ORDINANCE 00-26

**TO AMEND THE PRELIMINARY PLAN FOR THE GOLF COURSE COMMUNITY
PLANNED UNIT DEVELOPMENT**

**Re: 1000 West Gordon Pike
(Richland Construction, LLC, Petitioner)**

Subject: Case # PUD-14-00

PUD-14-00
 Revised Parcel Map
 Exhibit #5 - Open Space

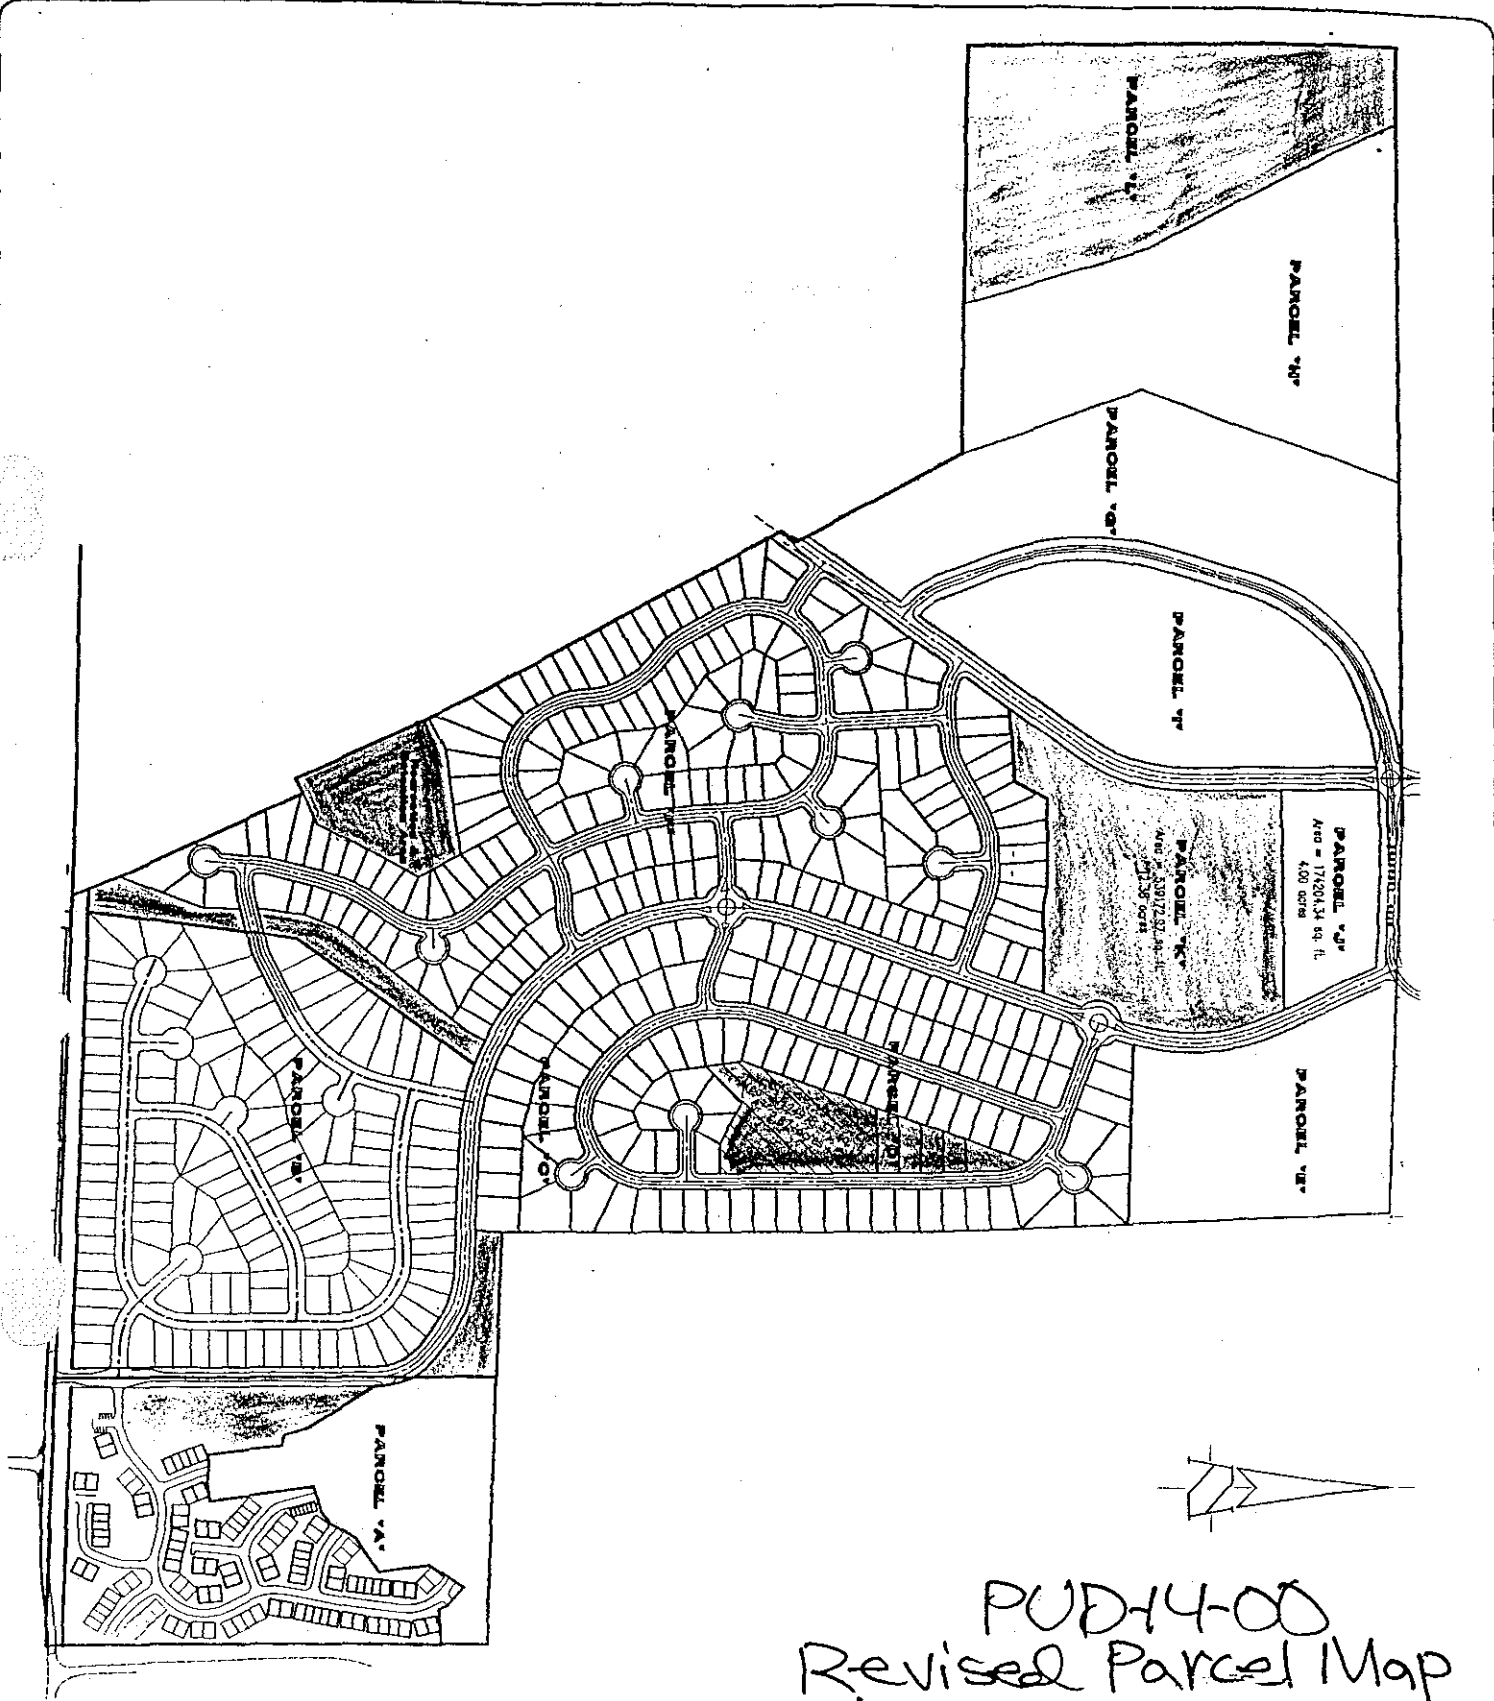
2) OPEN SPACE AND TREE PRESERVATION: As outlined in Exhibit #5, the revised PUD includes ample areas for both common open space and tree preservation. Within the development proposed for Parcel F, the petitioners have set aside a 3-4 acre area for stormwater detention. Because this area has very flat grades and will only hold water periodically, this acreage is very usable for open space activities. On Parcel D, the petitioners have committed to establishing a conservation area of over 4 acres of high quality forest. There will also be a playground area on Parcel D. In total, over 40 of the 235 acres has been set aside for common open space. This ratio is significantly greater than the common open space dedication ratios on such large PUDs as the Rogers Farm and the Canada Farm.

PUD-14-00
 Revised Parcel Map
 Exhibit #6 - Pathways Plan

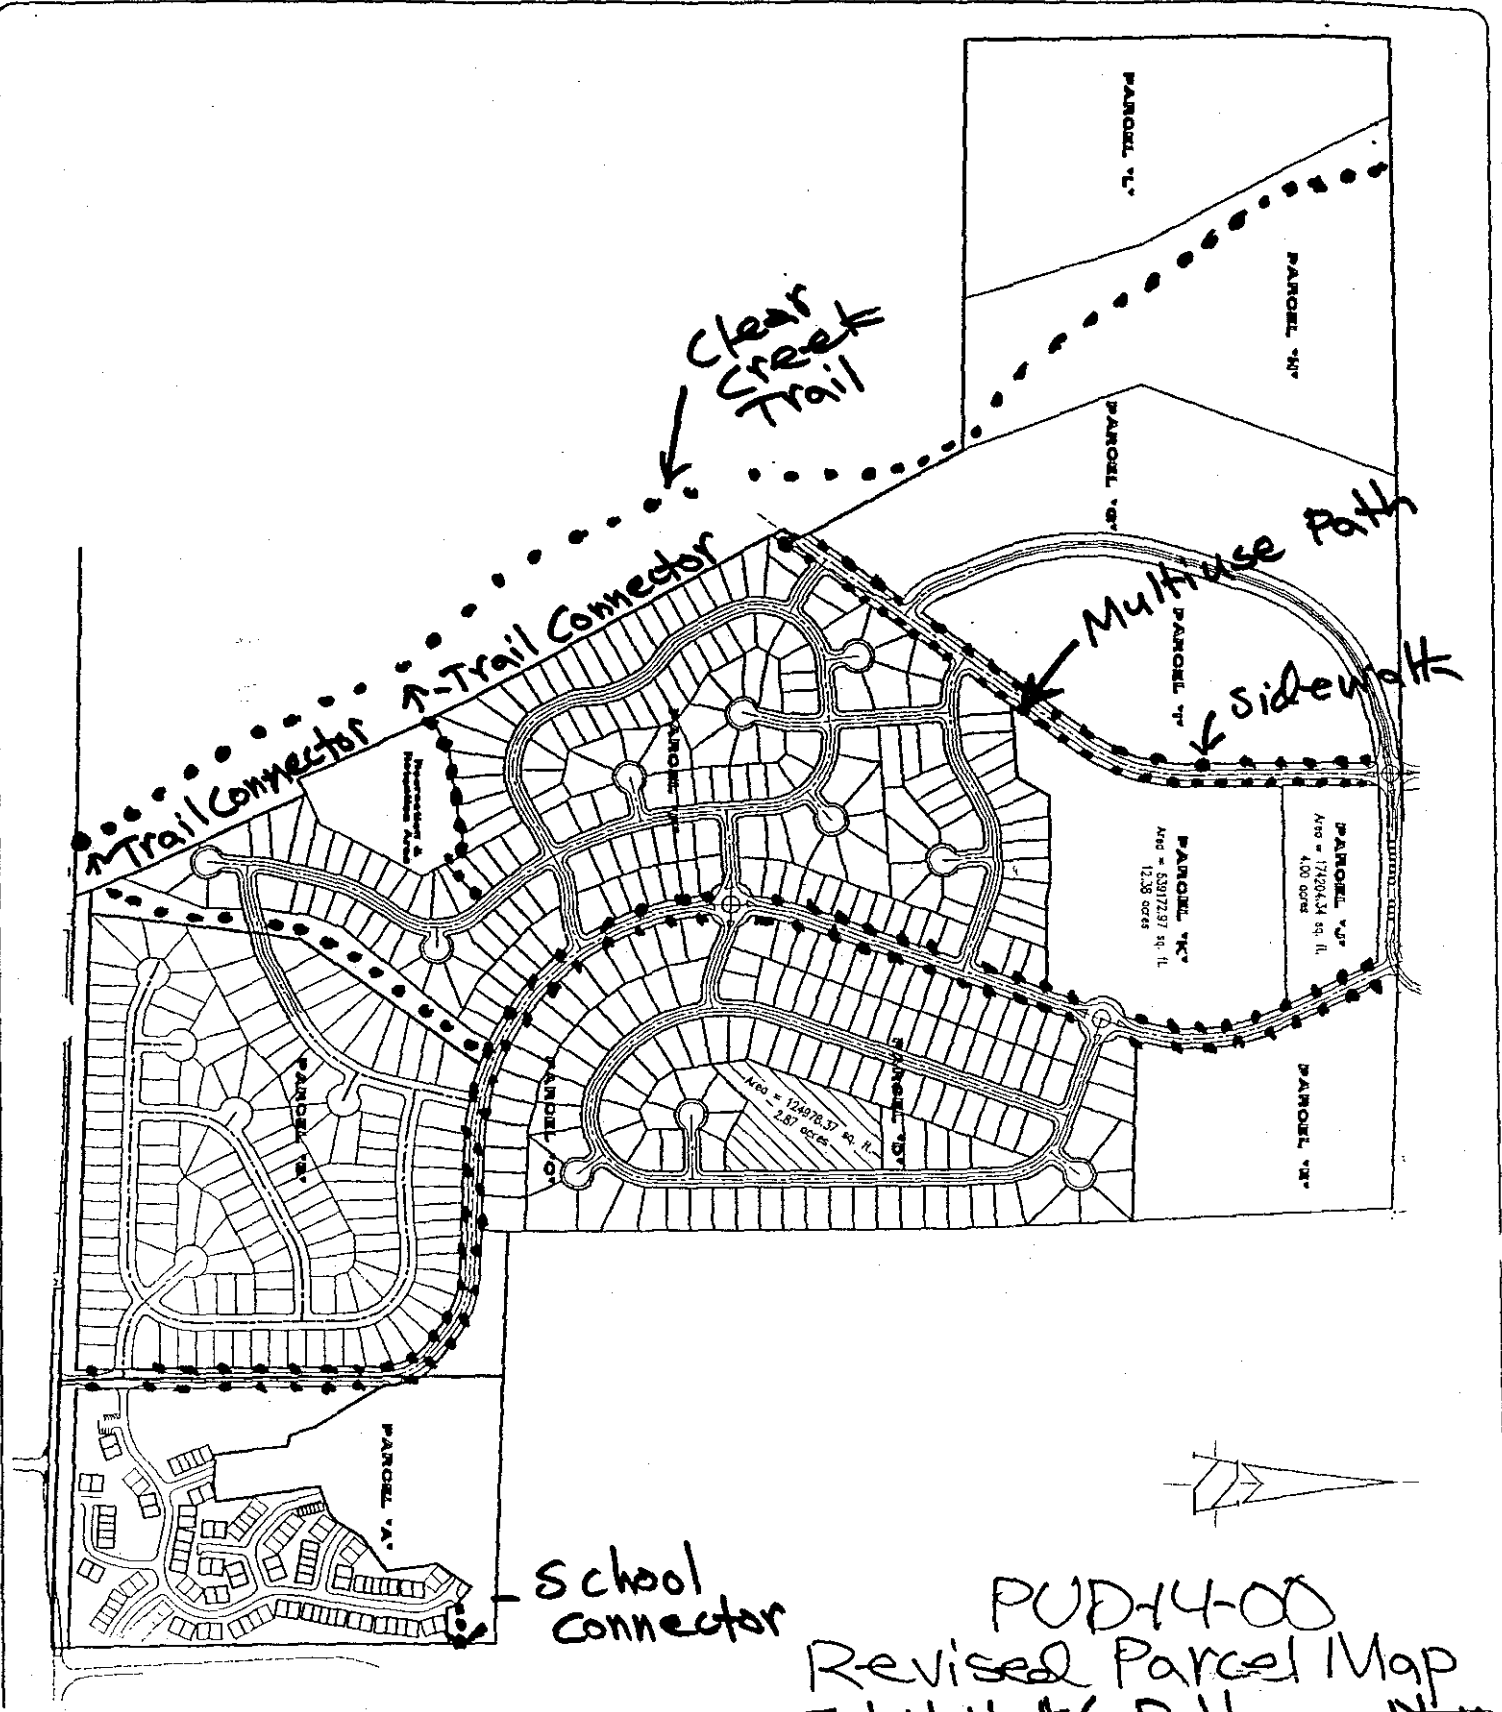
4) BICYCLE AND PEDESTRIAN ACCOMMODATIONS: As depicted in Exhibit #6, the petitioners have proposed substantial bicycle and pedestrian accommodations within the PUD. All of the internal public streets will contain sidewalks on both sides. Parcel A of the PUD also contains a sidewalk connection to Batchelor Middle School. The petitioners are extending two pathways (one between Parcels B and F, and one through Parcel F) to facilitate connections to the City's proposed Clear Creek Trail. Additionally, the proposed Adams Street extension will feature an 8-foot multiuse path on the east side of the roadway. This will connect to a similar multiuse path which will be constructed on the Woolery and Sudbury PUDs to the north. Due to a lack of Plan Commission consensus, staff has been directed to work with the Bicycle and Pedestrian Safety Commission to determine whether a multiuse path or on-street bike lanes could be constructed on Wickens Drive. The Plan Commission delegated this issue because they wanted better guidance concerning the impact of driveway cuts on these possible facilities.

Entry Detail

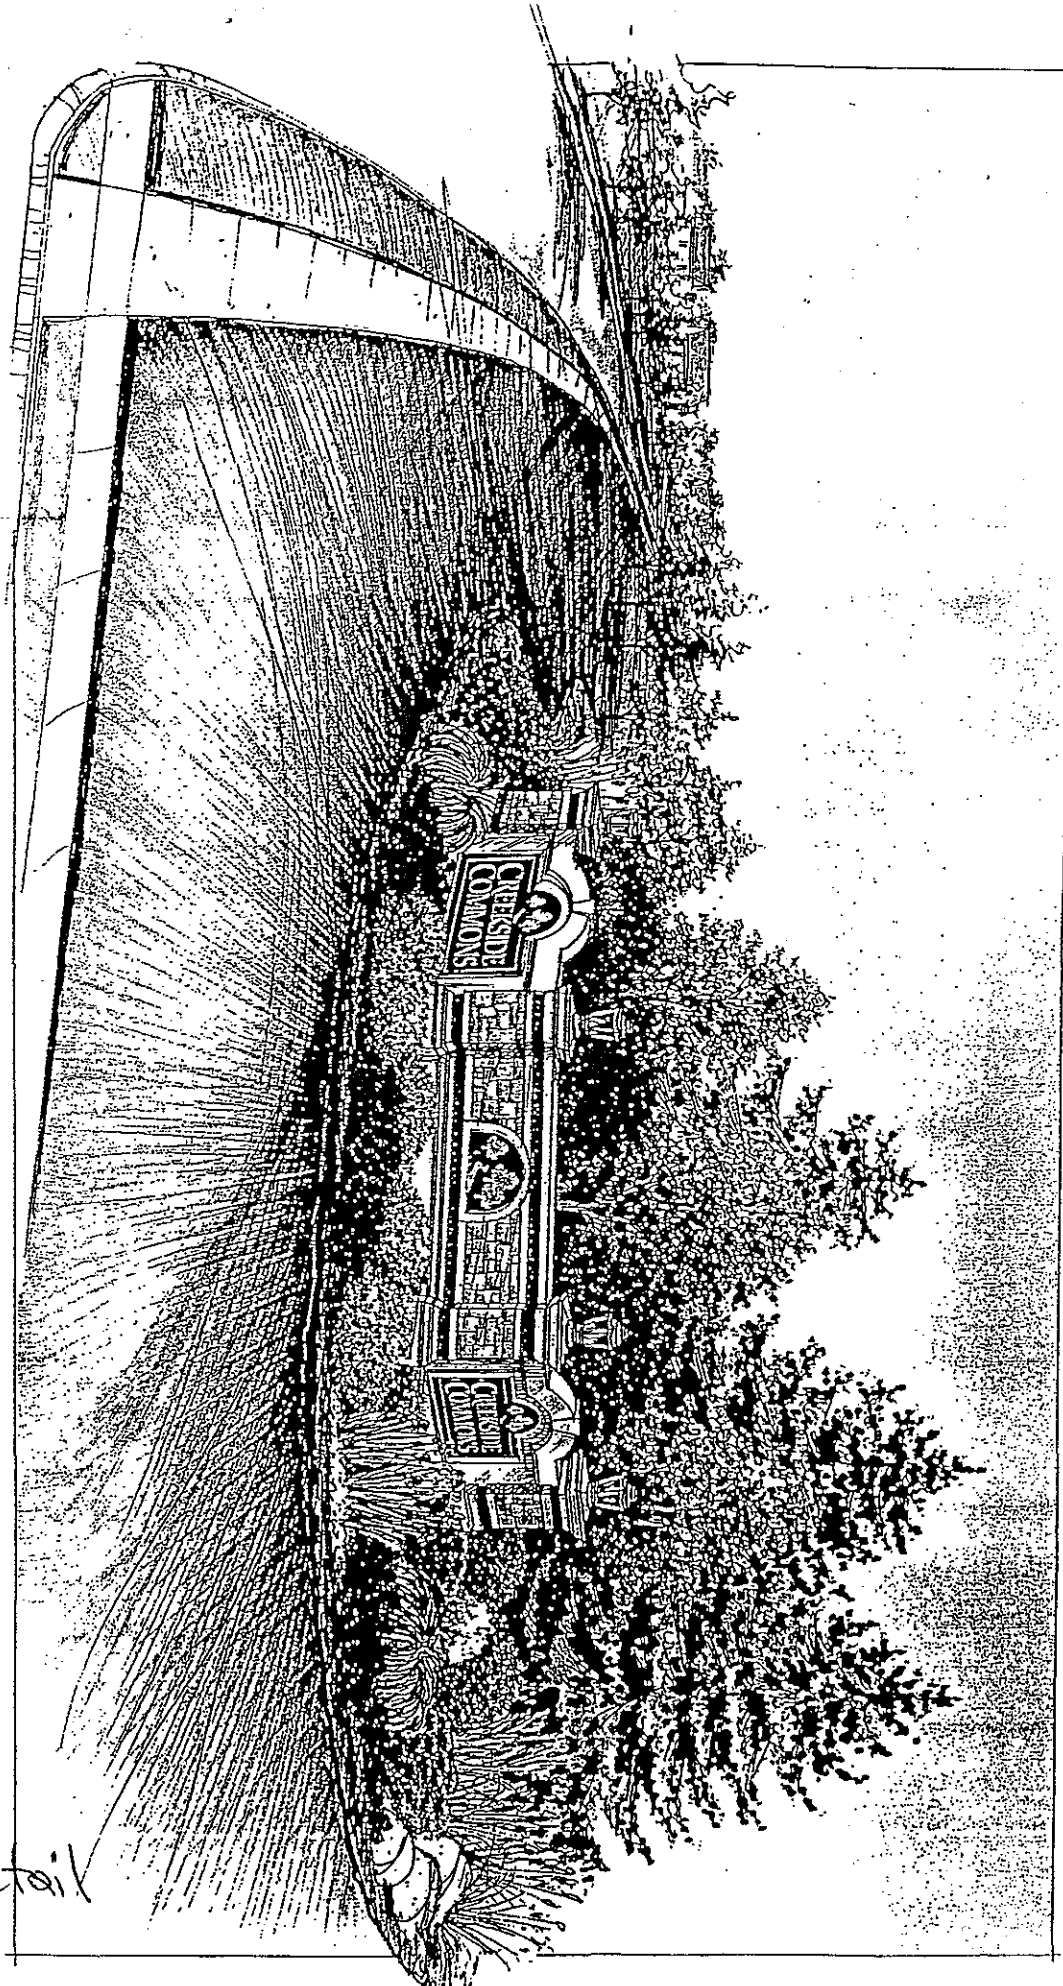
4. **Decorative features to enhance the proposed neighborhood:** I have enclosed an intersection detail depicting the use of the natural features of this site to create a common theme for this project. These features will consist of utilizing the Mill Blocks located on site as well as additional landscaping to create interesting focal points throughout the property. These will be used to compliment the features to be provided in the round a bouts.
